Midway City Council
7 September 2021
Regular Meeting

Resolution 2021-27 /
Watts Remund Farms
Master Plan Agreement
Second Amendment

CITY COUNCIL MEETING STAFF REPORT

DATE OF MEETING: September 7, 2021
NAME OF PROJECT: Watts Remund Farms Phases 4 & 5 PUD
NAME OF APPLICANT: Russ Watts – Watts Enterprises
AGENDA ITEM: Master Plan Amendment
LOCATION OF ITEM: 200 East 600 North
ZONING DESIGNATION: R-1-15

Exhibit 3

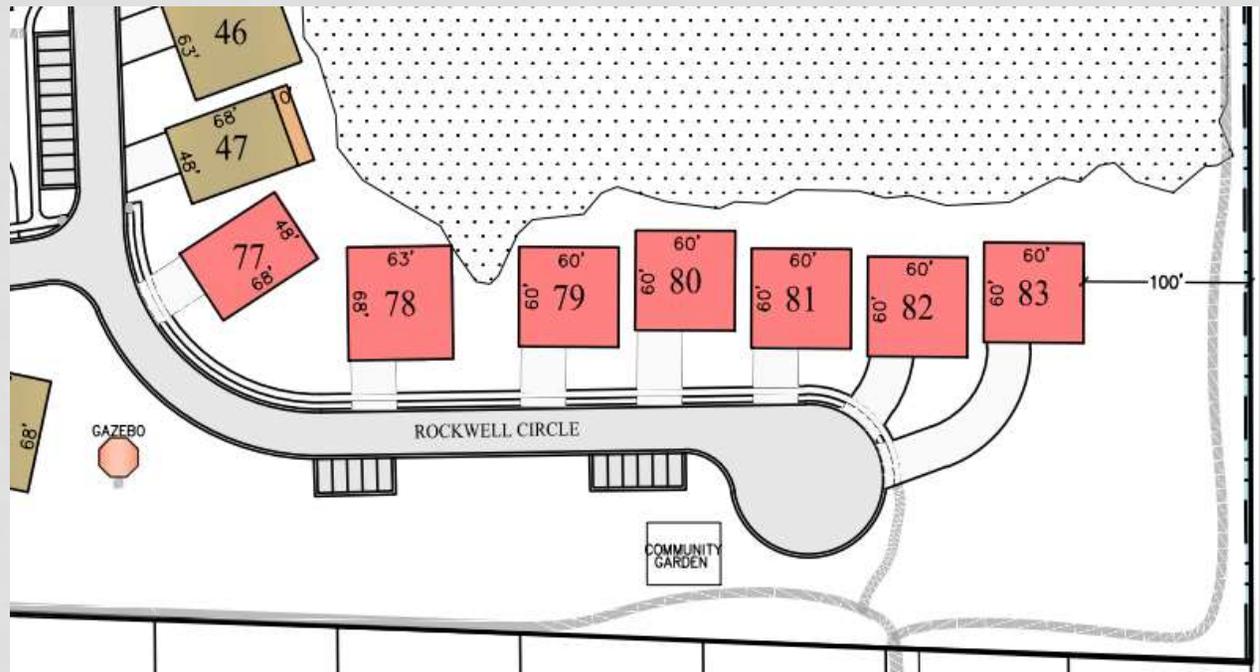
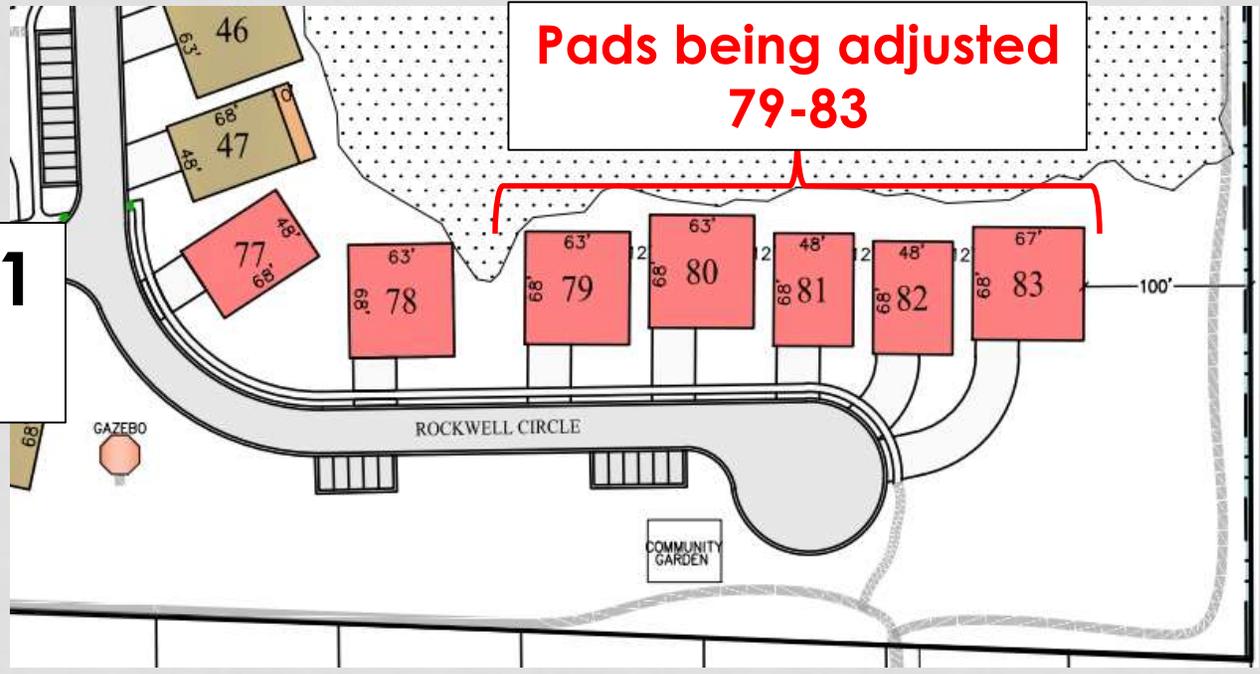
Setbacks to neighboring properties – The proposed adjustments to the building pads create an overall enlargement of the pads, resulting in some cases in reduced setbacks from the units to the neighboring properties. The current land use code for PUDs requires building setbacks from the peripheral boundary to be a minimum of 60’. This project is vested under a previous code requirement that allowed for a 30’ building setback from the peripheral boundary. In phase 4, it appears that the setbacks from the units to the east and south boundaries remain the same. In phase 5, it appears as though a few of the setbacks from the units to the neighboring properties to the east and south have decreased. The setback to the east decreased from 431’ to 412’. The setback to the south decreased from 42’ to 30’.

Pads being adjusted 79-83

Exhibit 6

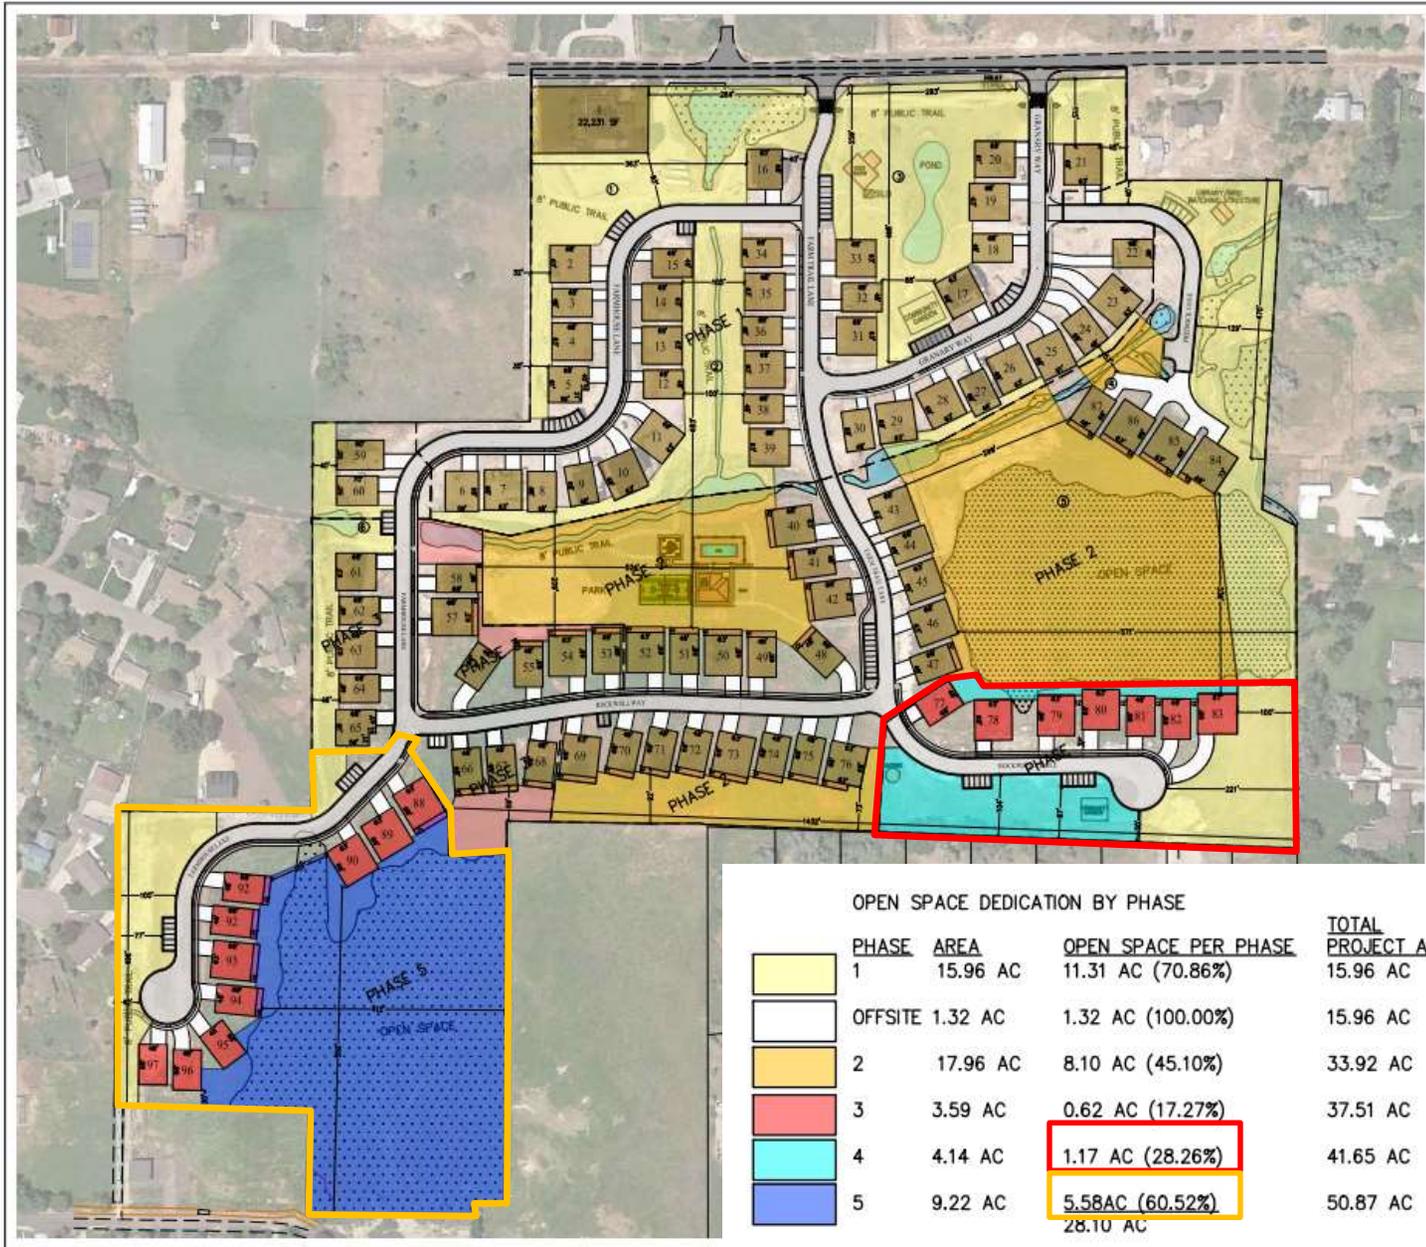
Open Space – The code requires that each phase to have sufficient open space to comply with the requirements of the code. For example, phase I must have at least 50% open space for that particular phase. If phase I has 75% open space, then phase II only needs to have 25% open space if both phases are equal in acreage. Although the applicant is enlarging some footprints and decreasing others, the overall open space for the project decreases by 7,840 SF, or 0.18 acres due to the proposed adjustments. The proposed adjustments decrease the overall open space percentage from 55.51% to 55.24 %. The applicant has provided an amended open space plan and the proposed plan appears to comply with the 50% open space per phase requirement for the development.

Overall open space decrease of 0.13 acres (0.27%)

Exhibit 7

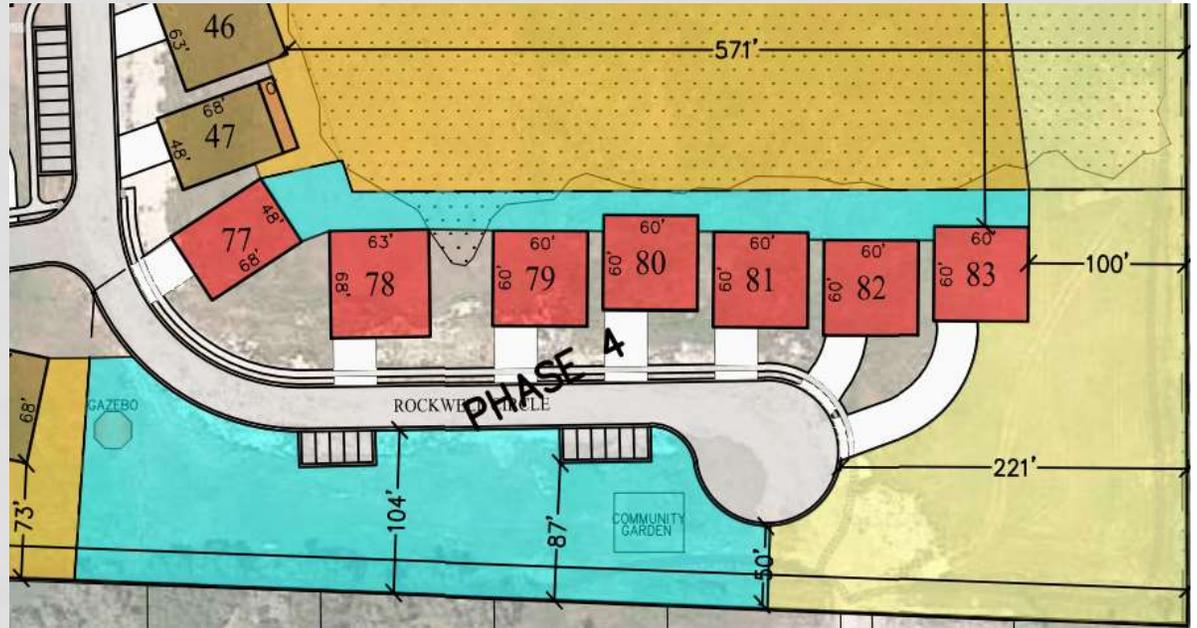
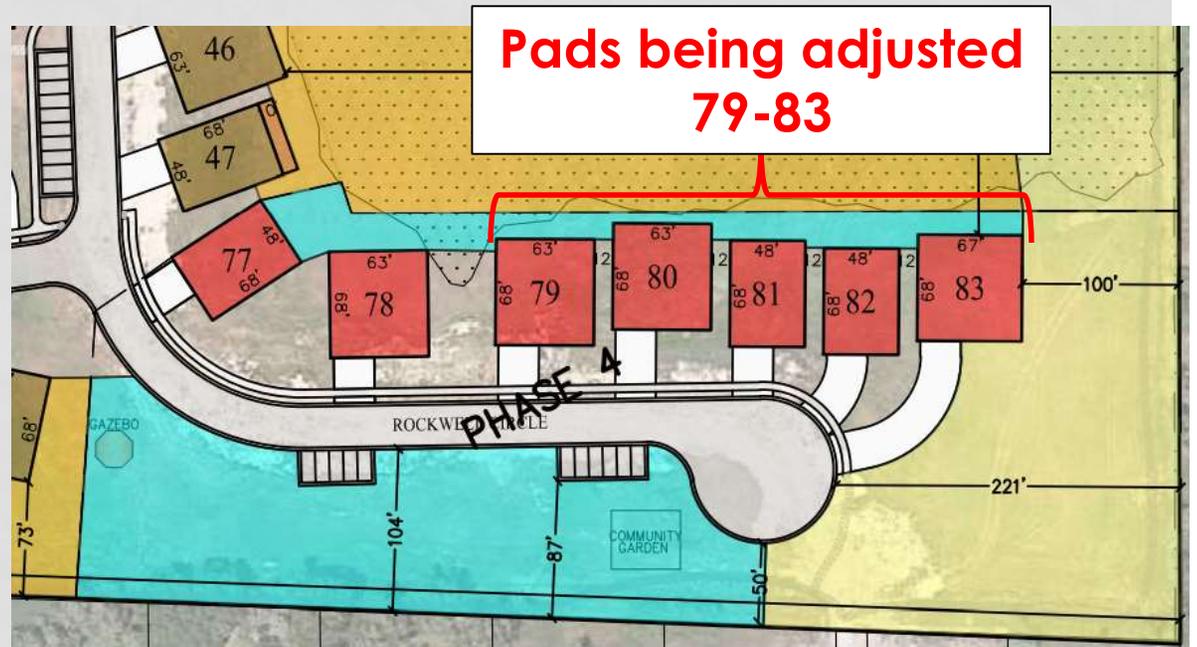
Setbacks to property lines remain the same

Exhibit 9

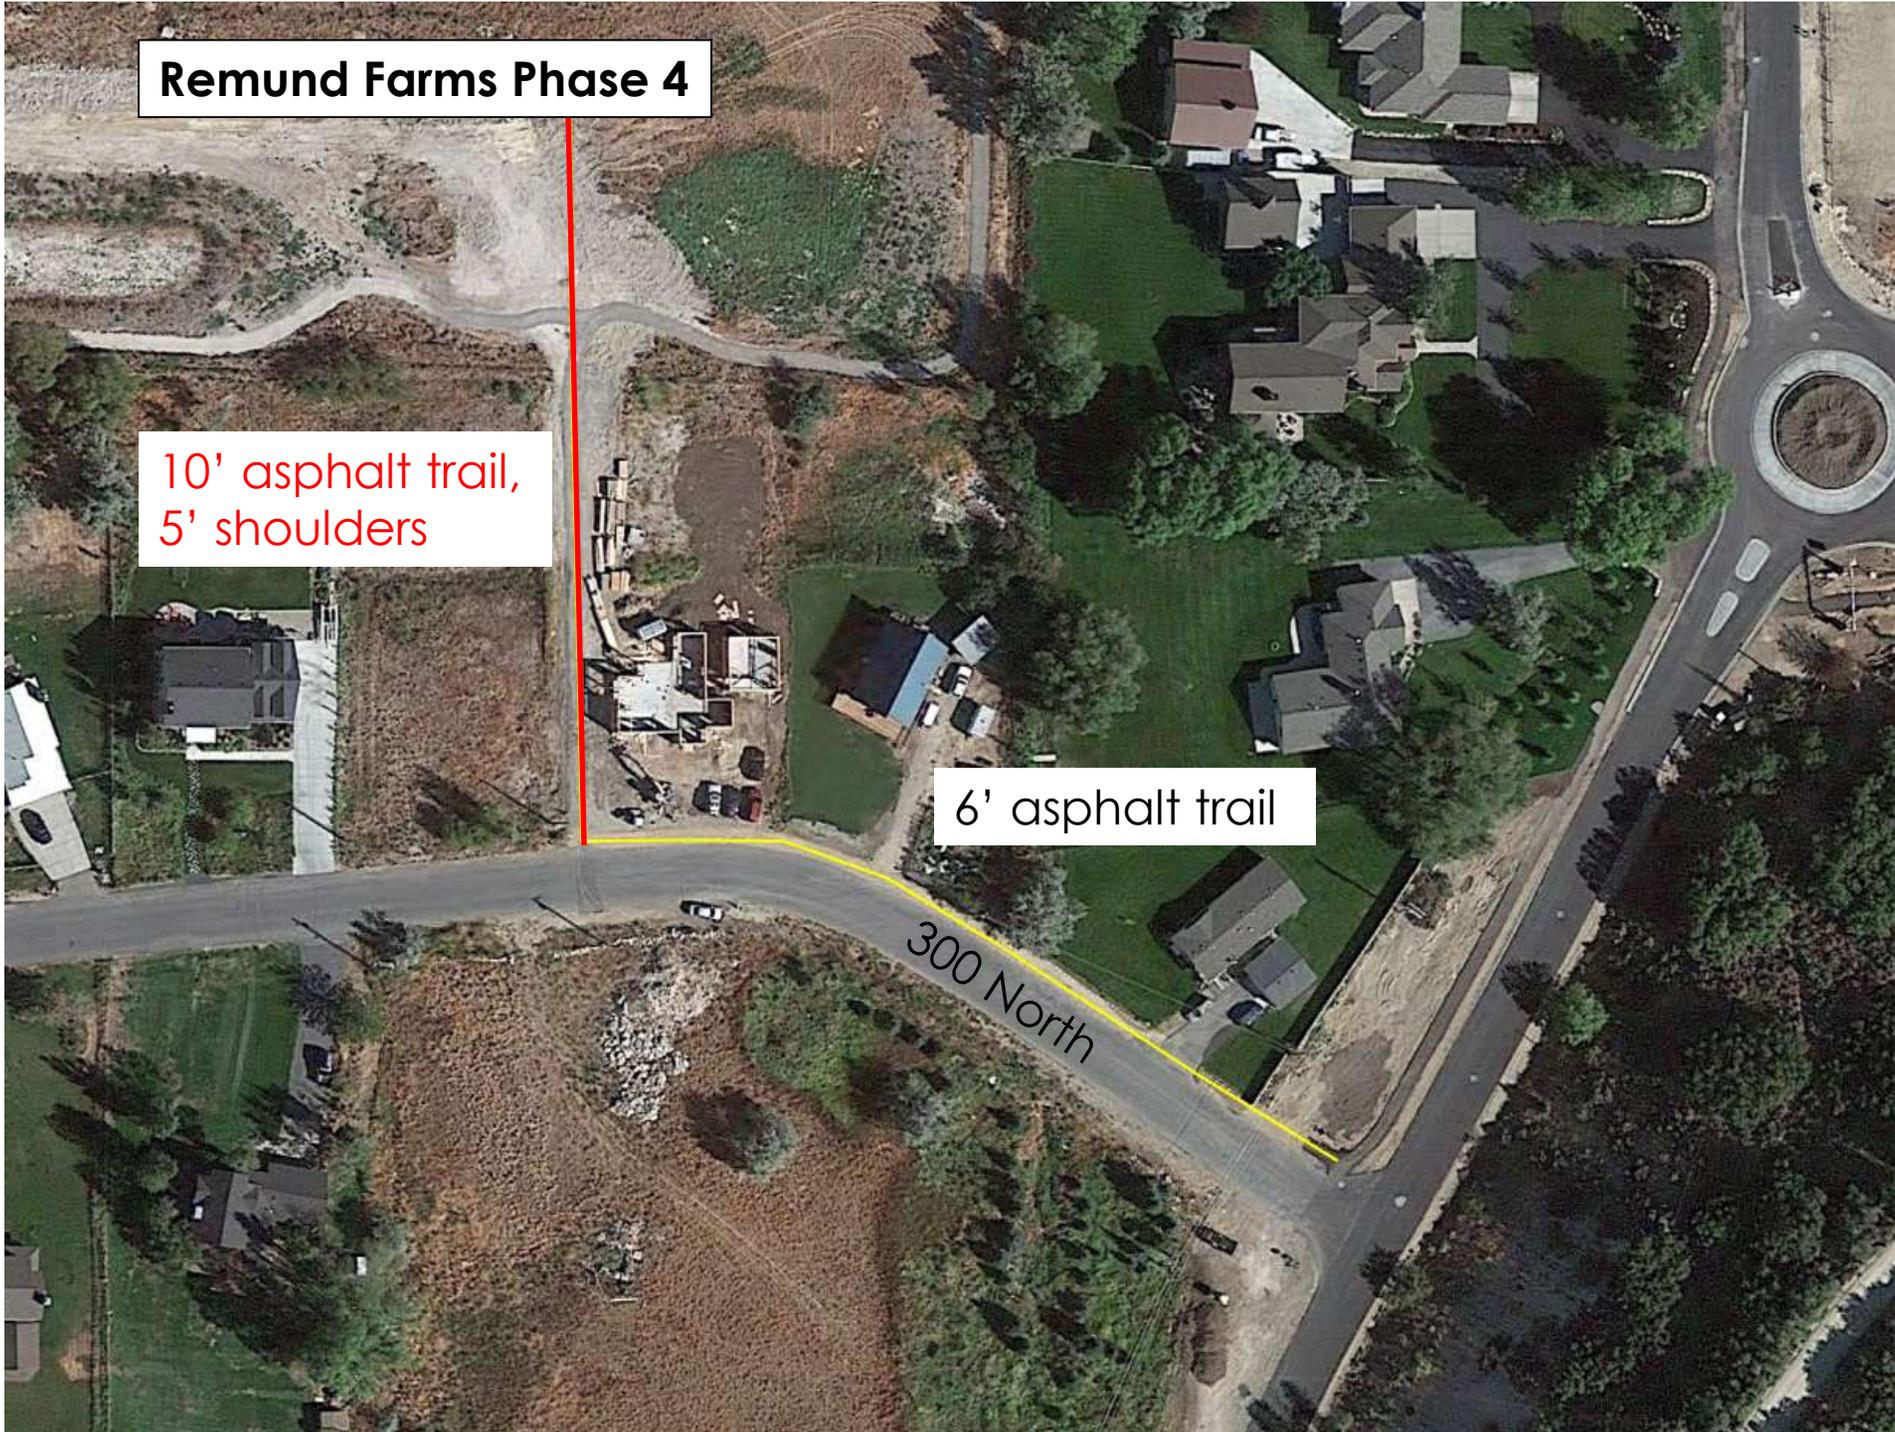
- The first condition is that the applicant build and pave the trail that he previously installed from the corner of River Road and Swiss Paradise Lane to Rockwell Circle cul-de-sac sidewalk in Phase 4. The section along Swiss Paradise Road would be a 6’ asphalt width while the section running over the easement on lot 3 in Swiss Paradise and connecting into the Rockwell Circle cul-de-sac would be 10’ in width. The added width would create a hard

10' asphalt trail,
5' shoulders

6' asphalt trail

1. The applicant will be required to pave an existing trail along Swiss Paradise Lane to be 6’ in width. They will also be required to pave a 10’ trail connecting the Swiss Paradise Lane trail, along the easement over Swiss Paradise lot 3 and into the sidewalk at the end of the cul-de-sac in phase 4 of Remund Farms.
